RAI-7

Description of Deficiency

The information in TR Section 2.6.2 does not meet the applicable requirements of 10 CFR 40.41(c), using the review procedures in Section 2.6.2 and acceptance criteria in Section 2.6.3 of the SRP.

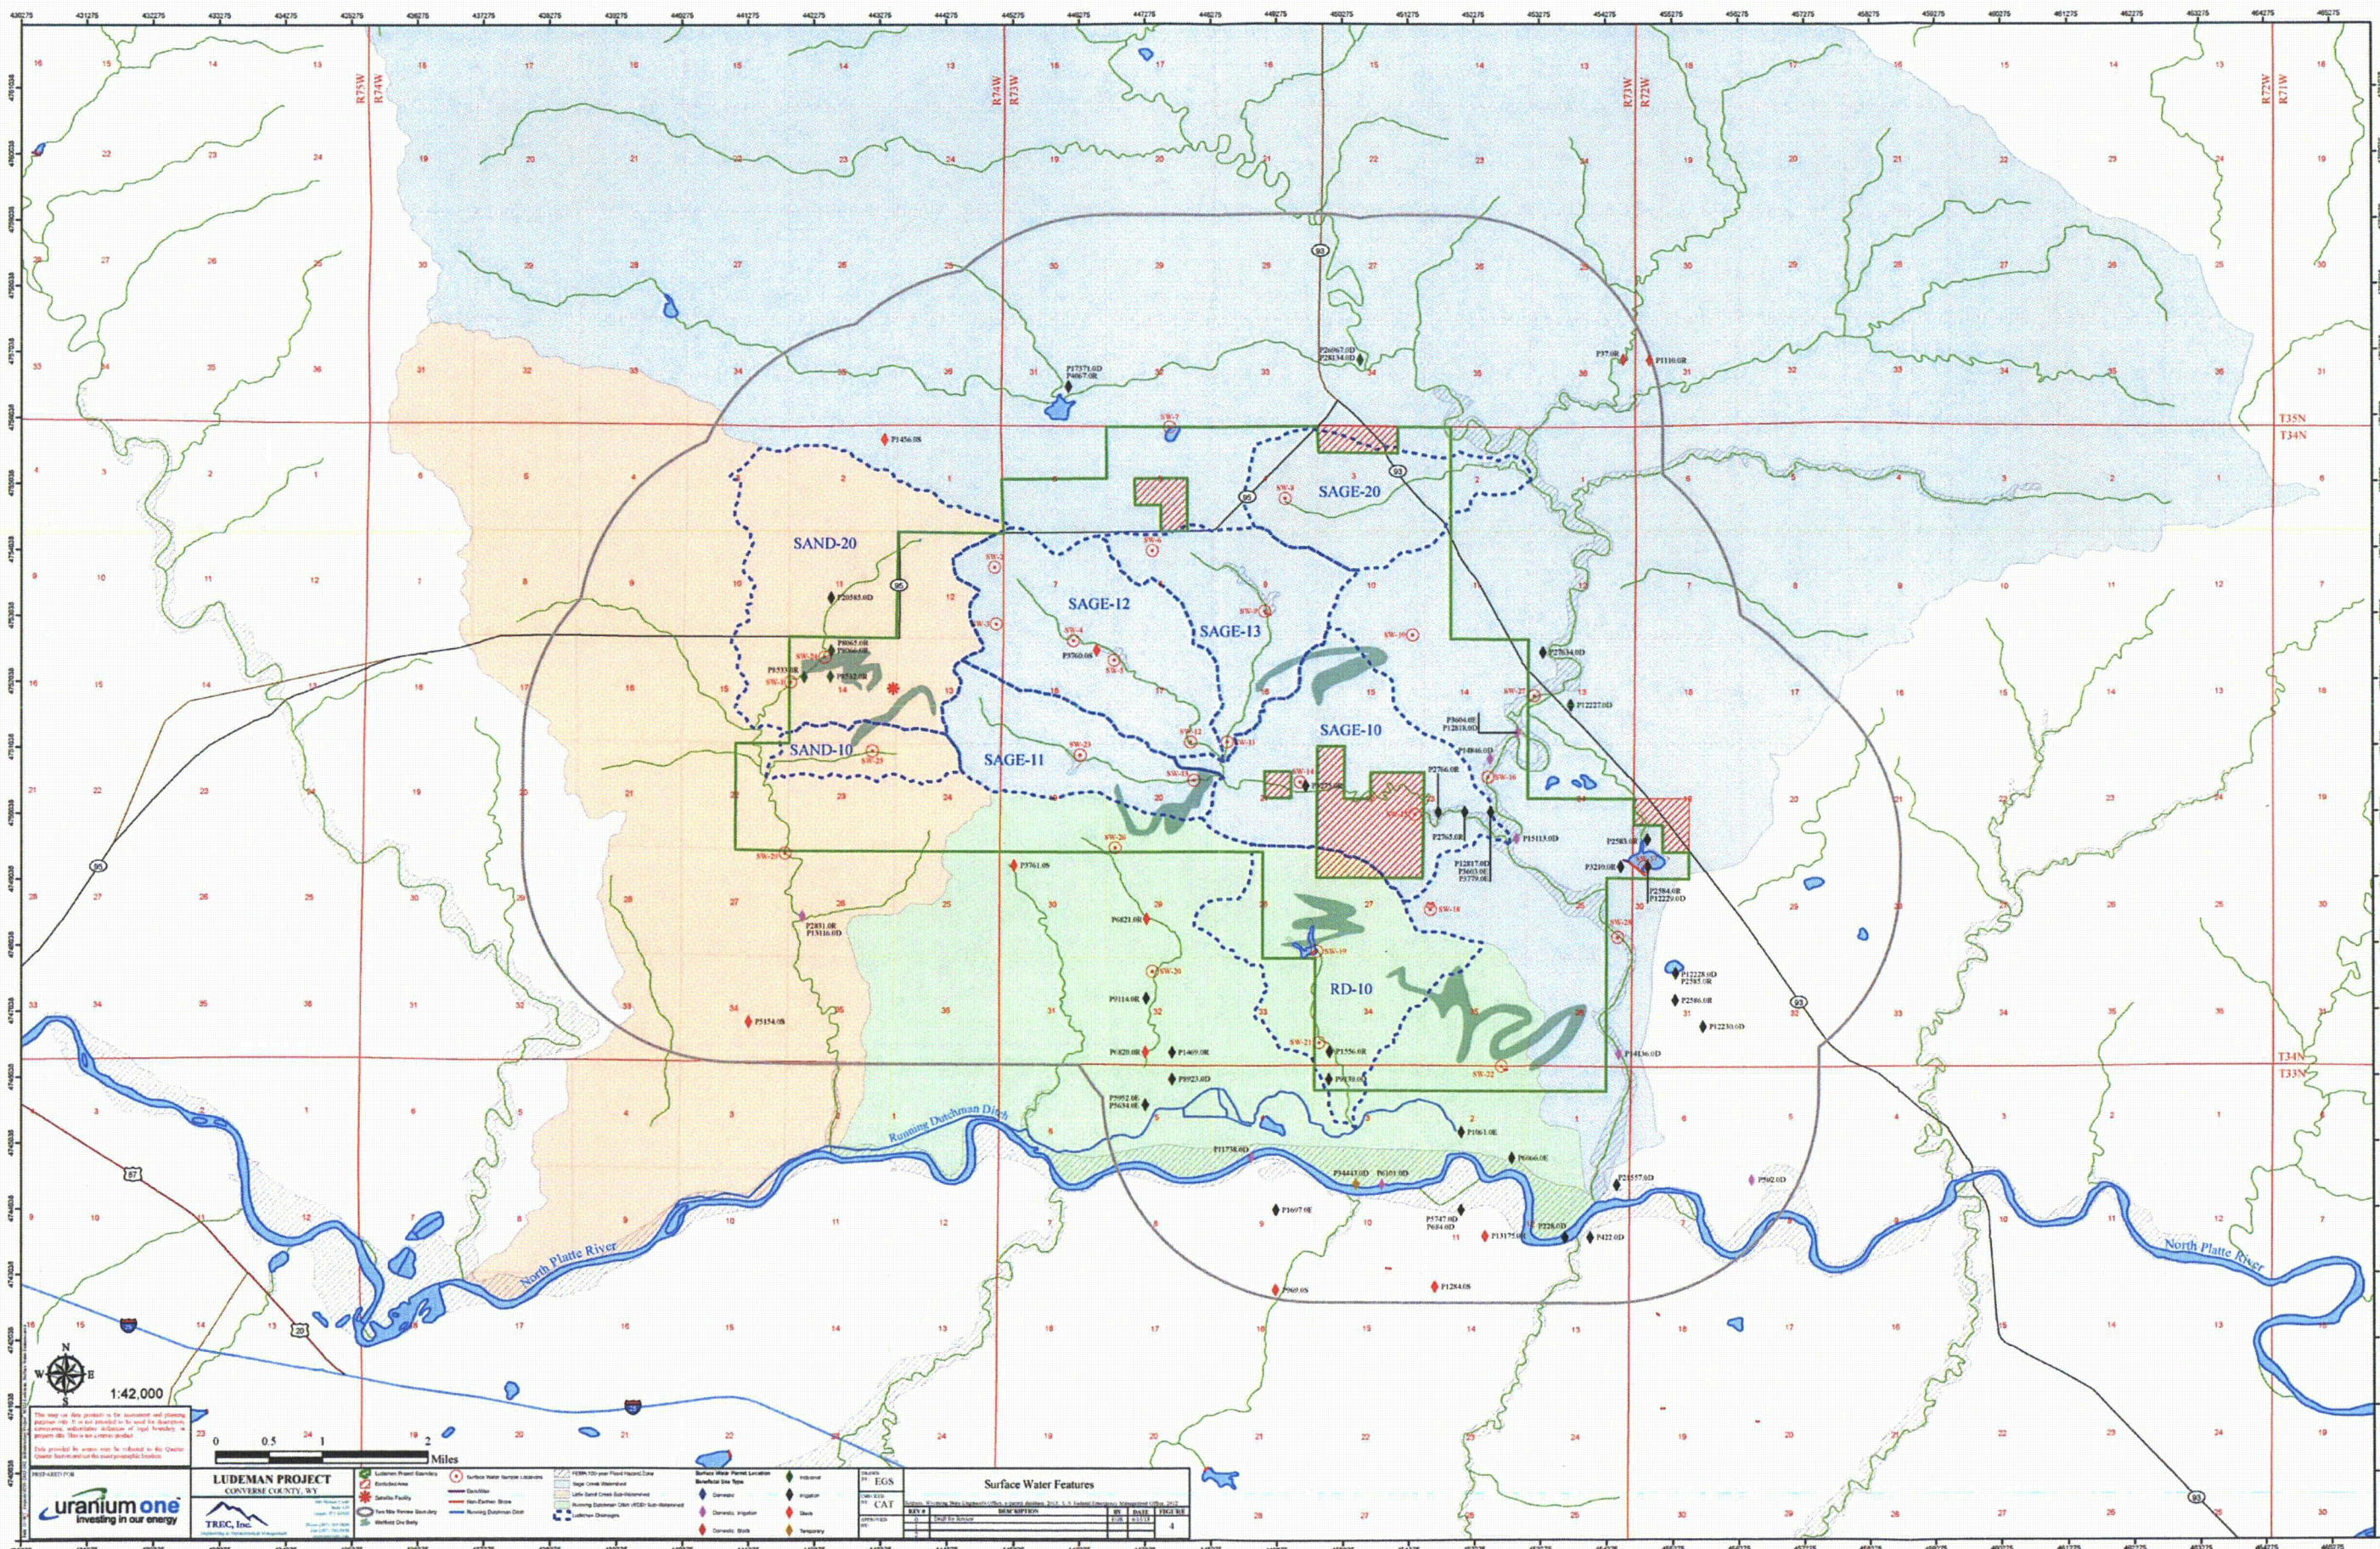
Uranium One identified several surface water impoundments within the license area. Approximately 195 individual water bodies were identified ranging from 28 ft² to 5.1 acres. The larger ponds were described as drainages which had been impounded for livestock. Some of these stock ponds were supplied by windmills. The two largest ponds were identified as Gilbert Lake in the eastern portion of the license area which was 16 acres and 6 inches deep when surveyed in 2008. Another depression pond was located in the northern portion of the license area and was 4.8 acres and 12 in deep.

Uranium One did not appear to provide a listing of any surface water rights associated with drainages or impoundments within the license area. However, staff found this information in Addendum 2.7-A mingled with the groundwater rights. Uranium One did not provide a map showing the surface water rights in the license area.

Uranium One should provide the surface water rights in a separate addendum from groundwater rights for a 2 mi buffer around the license area. In addition, NRC requests that Uranium One provide a map(s) identifying the surface water rights within 2 km of the proposed wellfields and surge ponds separately for the Leuenberger, North Platte and Peterson Satellites.

The Ludeman Project operations now propose to employ a single satellite facility; thus, there is a single corresponding figure identifying surface water rights for the project area and 2-mile buffer. The figure referenced and presented in the response to RAI-12(attached below) identifies the updated surface water rights within the proposed project boundary and a 2-mile buffer. Uranium One makes the commitment to restructure tables located in the TR Addendum 2.7 to separate groundwater and surface rights and list these rights individually. Surface water impoundments not identified by a permit number on the below attached map do not appear to have surface water rights filed with the Wyoming State Engineers Office (SEO) and no information could not be found within the SEO database for these surface water impoundments. The reviewer is reminded that this project is located on private lands, and permits for surface impoundments may not have been filed by the land owners at the time the impoundment was constructed.

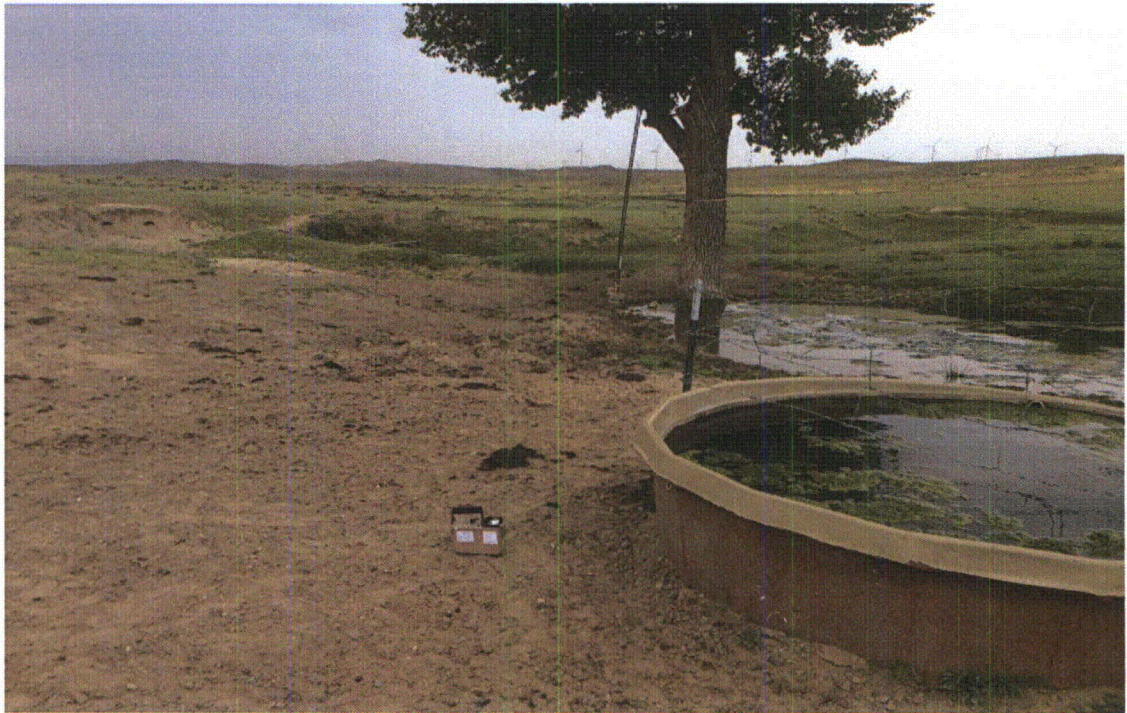
Staff's review of the surface water sampling results identified two locations where measurements appeared to show anomalous values for cations, anions, and radionuclides. The two locations of concern are SW-1 and SW-29 located down-stream of the Leuenberger Satellite on Little Sand Creek. SW-1 is located just west of the Leuenberger Satellite and SW-29 is located further downstream from the satellite. As shown in the RAI 17 Surface Water Quality table SW-1 and SW-29 showed anomalously high average values for bicarbonate, chloride, conductivity, sulfate, calcium, sodium, magnesium, uranium and gross alpha. The values of these constituents at SW-24 on Little Sand Creek directly up-gradient of the Leuenberger Satellite were below the license area average.

Uranium One did not address the surface water quality anomalies at SW-1 and SW-29. Staff does not have reasonable assurance that Uranium One has characterized surface water quality at Little Sand Creek.

Uranium One should evaluate the source of anomalous surface water quality at SW-1 and SW-29 at Little Sand Creek.

It is possible there are sources within the project area that may contribute to the anomalous cations and bicarbonate, chloride, conductivity, sulfate, calcium, magnesium uranium and gross alpha; although, Uranium One is currently unaware of any documented spills or other agricultural sources in these areas.

Uranium One has done some further investigation and from discussions with the land owner representative Stock Well 12 (STW12) may actually be within the Wyoming State Engineer Office (SEO) database as cancelled well P4988.OP or Smith Well #5. STW12 is a seep or spring that feeds into little sand creek approximately 100 yards above the baseline sampling point for SW-1. Baseline water sample results from STW12 collected in June 29, 2009 and December 7, 2009 indicate elevated values for cations, anions, bicarbonate, chloride, conductivity, sulfate, calcium, sodium magnesium, and radionuclides. Uranium One releases that NRC does not currently have the analytical results for the December 2009 sampling event as the results were not reported until after the permit application was submitted. A copy of the update water quality for STW12 has been included for reference in this response and will incorporated into Appendix 2.7-E as the document is updated. SW-1 and SW-29 are

both downstream of where STW-12 waters feed into little sand creek and water quality would appear to be impacted from these waters. Regardless of these impacts water quality would be considered background water conditions. Photos of the location of SW-1 in relation to STW12 are included for reference purposes below:

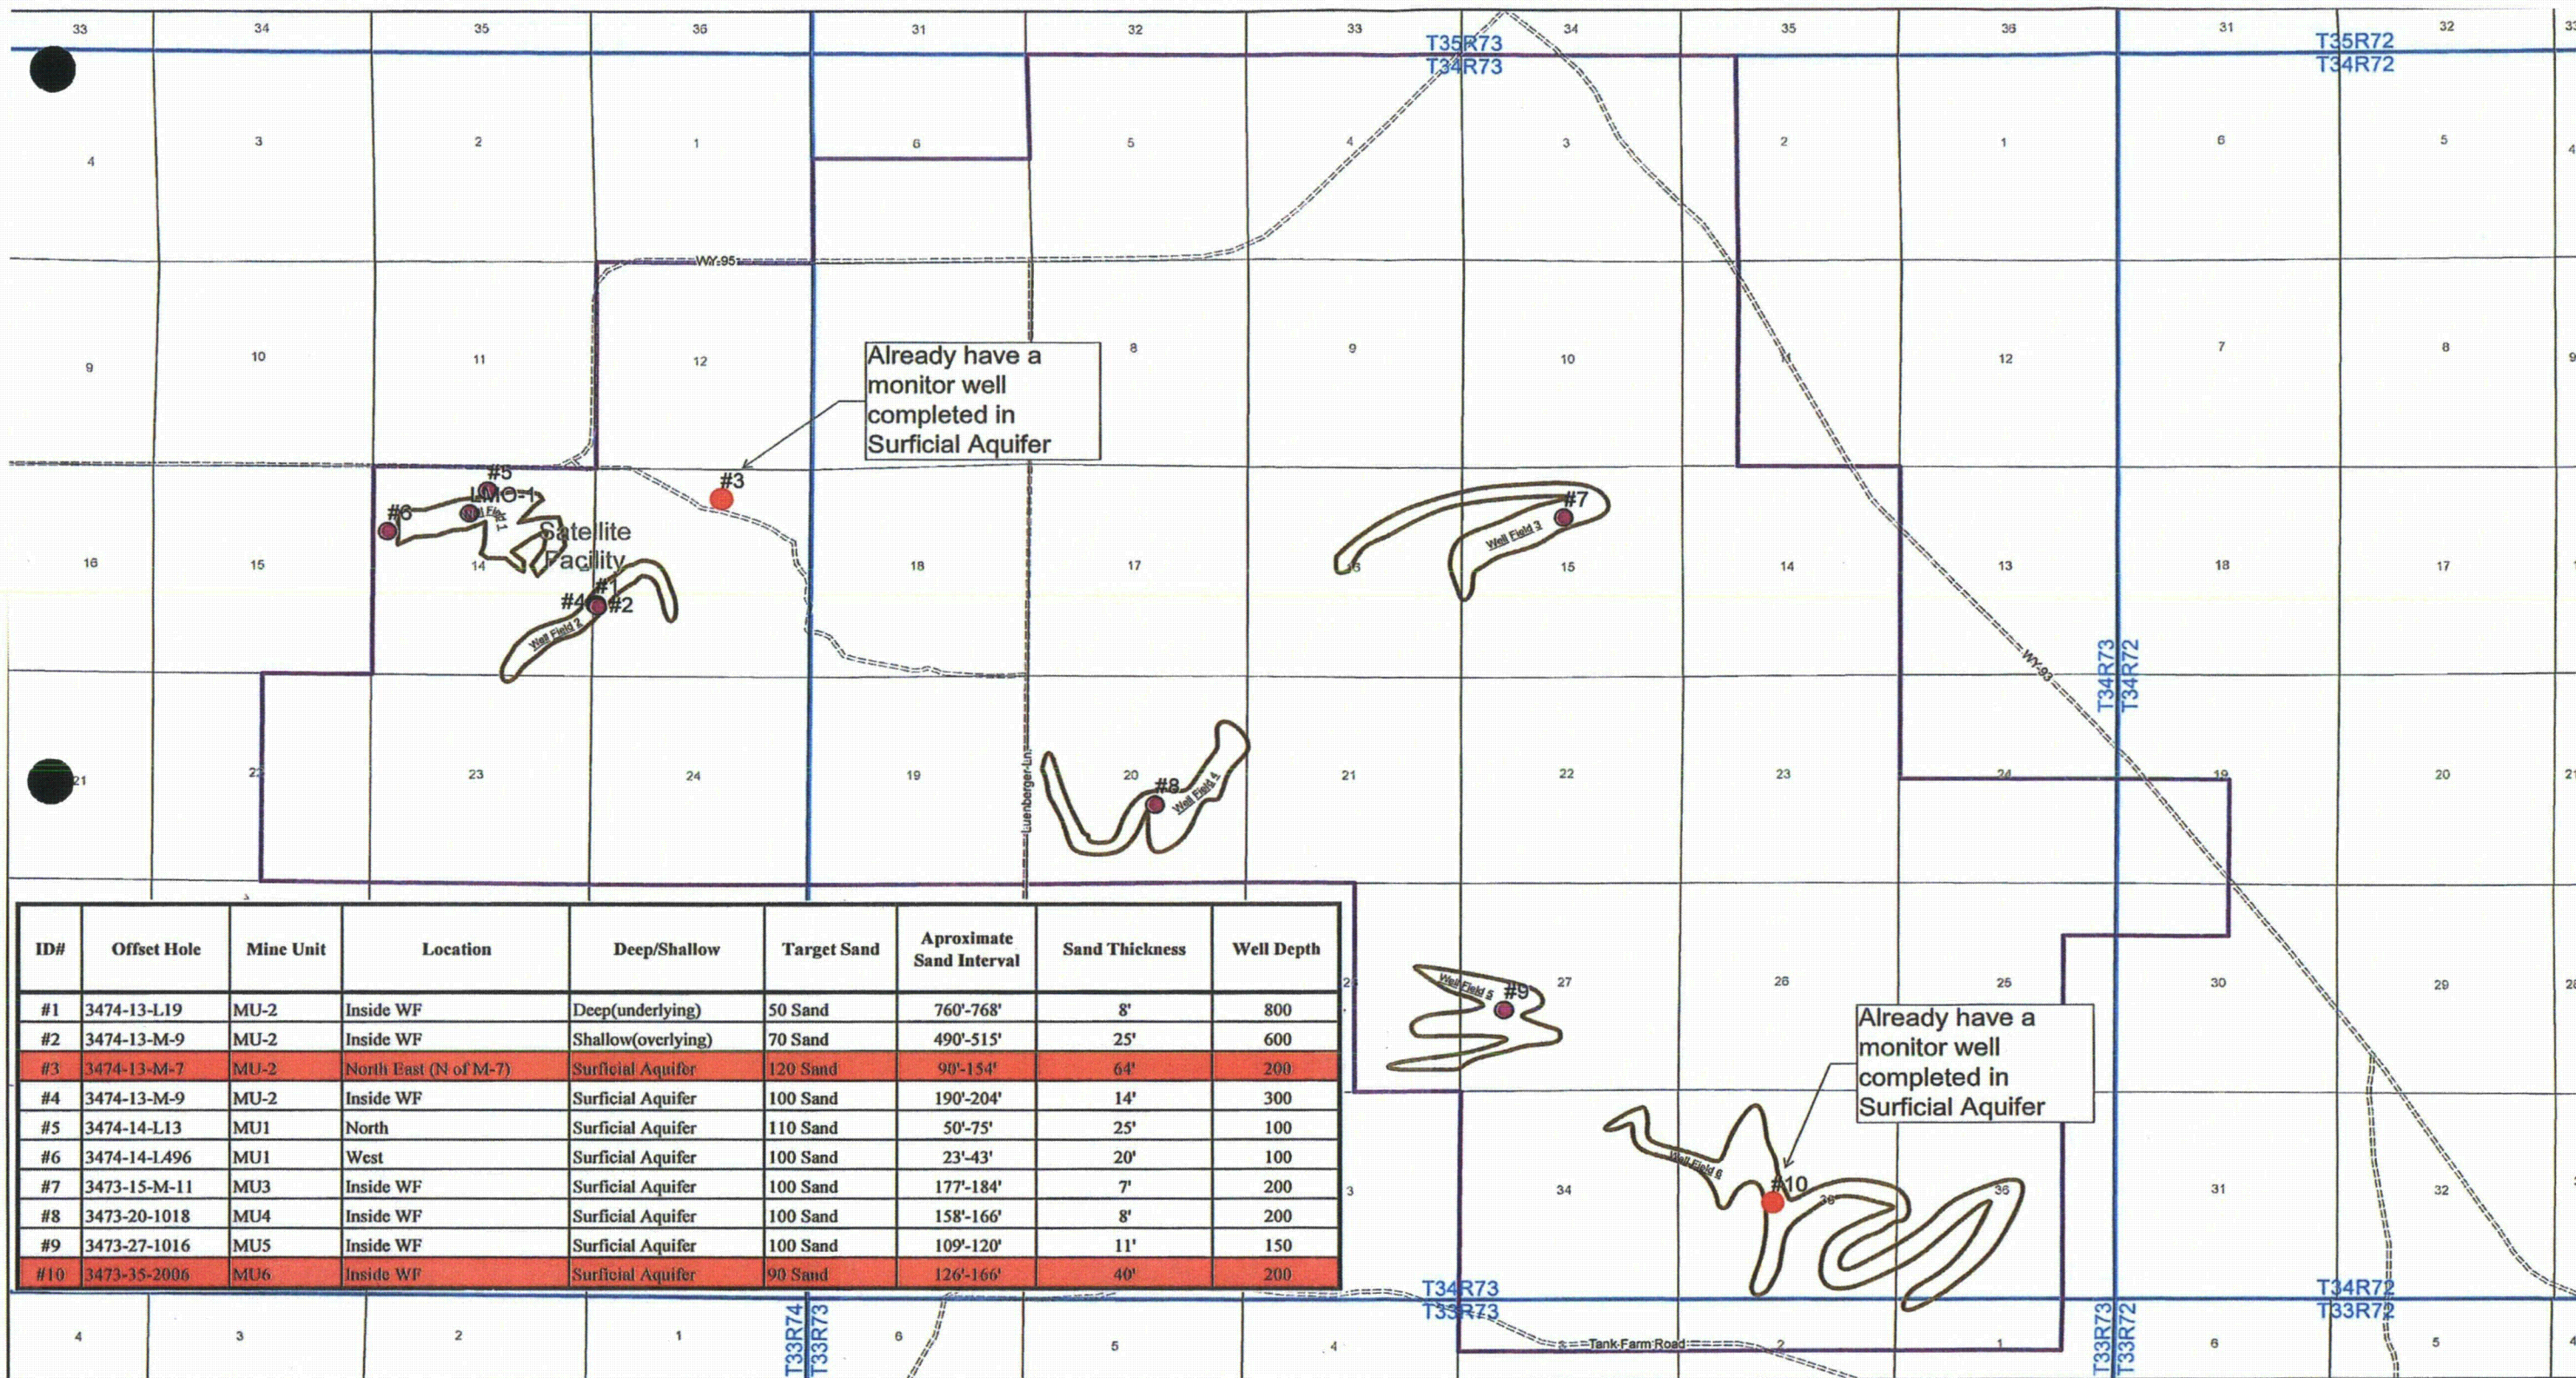
Uranium One did not characterize the surficial (uppermost) aquifer at the proposed Leuenberger Satellite. Characterization is critical to assess if spills and leaks from proposed surface operations and subsurface piping will contaminate the uppermost aquifer which may be connected to surface water. Staff cannot evaluate or provide reasonable assurance of the safety of operations without characterization of the surficial (uppermost) aquifer.

Uranium One should characterize the surficial (uppermost) aquifer(s) at the Leuenberger Satellite. Provide a map of the depth to the uppermost aquifer(s) at the Leuenberger Satellite within a 2 km buffer around Wellfields 1, 2 and 3 and the proposed surge ponds. Uranium One should discuss any hydraulic connection between the uppermost aquifer(s) with surface water features and the drainages, particularly Little Sand Creek, at the Leuenberger Satellite.

The structure maps and net depth isopachs and the location of the shallow existing wells should be used to select monitor points for the uppermost aquifer. If possible, Uranium One should attempt to measure water levels in any wells that appear to be completed in uppermost aquifer.

This data may provide a preliminary indication of the direction of groundwater flow in the uppermost aquifer in the vicinity of the 3 satellite areas.

Uranium One proposes monitor wells be installed in the 120 Sand (if that unit is water-bearing) in the vicinity of the Luenberger Satellite. Additionally monitor wells should be installed in the 110 Sand (if that unit is water-bearing) in areas where the 120 Sand is not present. Having these points of control for water level measurements will provide for assessment of the orientation of the potentiometric surface and direction of groundwater flow within the uppermost aquifers.
